STATE OF CONNECTICUT
CONNECTICUT SITING COUNCIL

RE: **PETITION NO. 984** - BNE Energy, Inc. petition for a declaratory ruling that no Certificate of Environmental Compatibility and Public Need is required for the construction, maintenance, and operation of a 4.8 MW Wind Renewable Generating facility located on Winsted-Norfolk Road (Route 44), Colebrook, Connecticut.

**Petition 984: BNE Energy
Colebrook North, Connecticut
D&M Interrogatories, Set One**

Figure 1

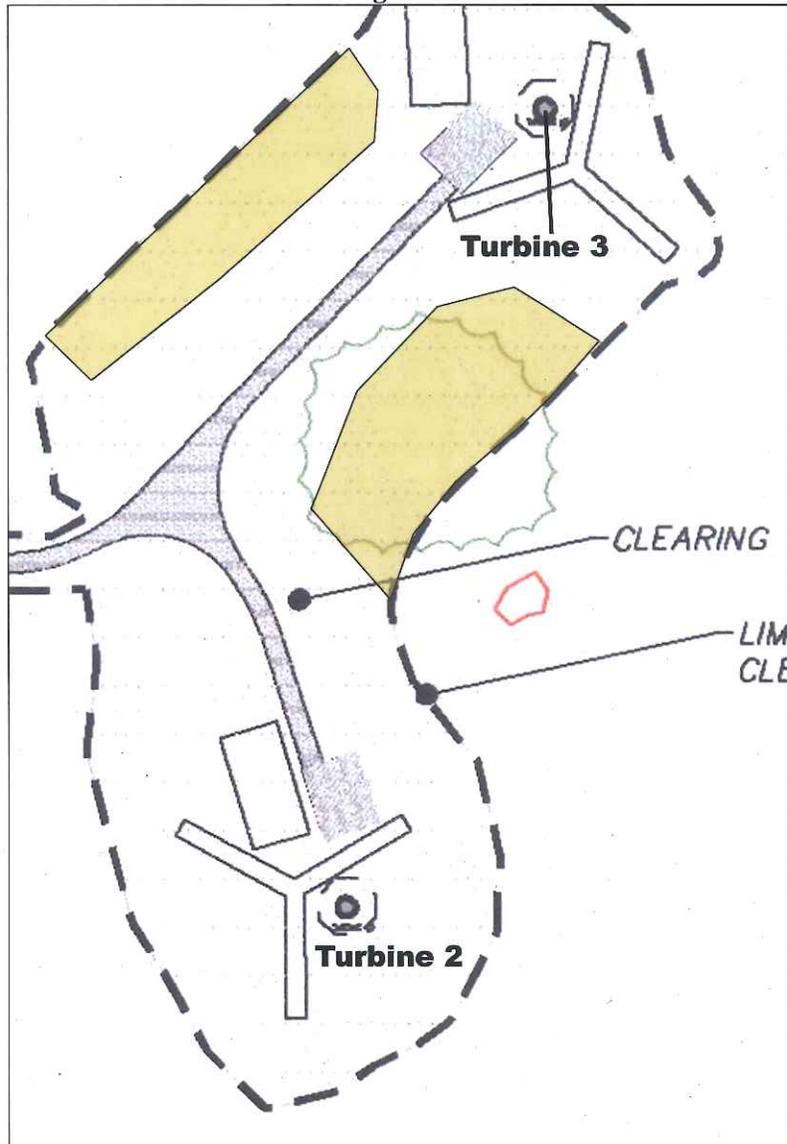
5. Will erosion and sedimentation controls be installed for the Rock Hall Road reconstruction?
6. Could less of the areas indicated in light orange in Figure 1 be cleared for this project?

Figure 2

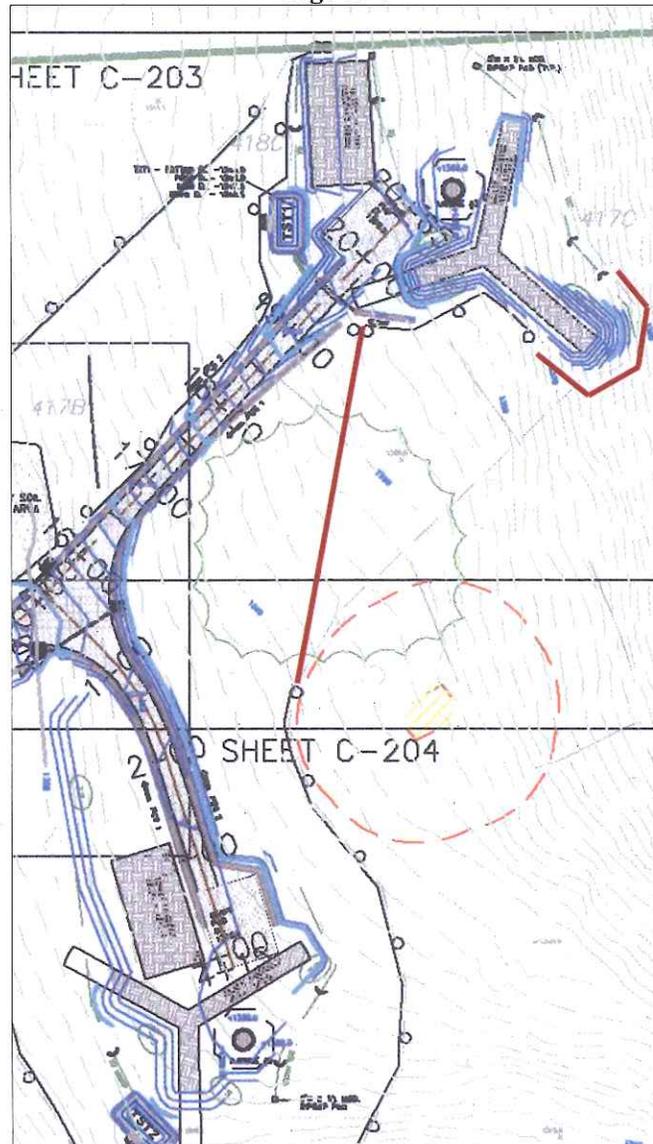
7. Explain why erosion and sedimentation controls are not shown as being installed in the areas indicated in red in Figure 2.
8. How will trees be prevented from taking hold in those cleared areas that are meant to remain as meadow?
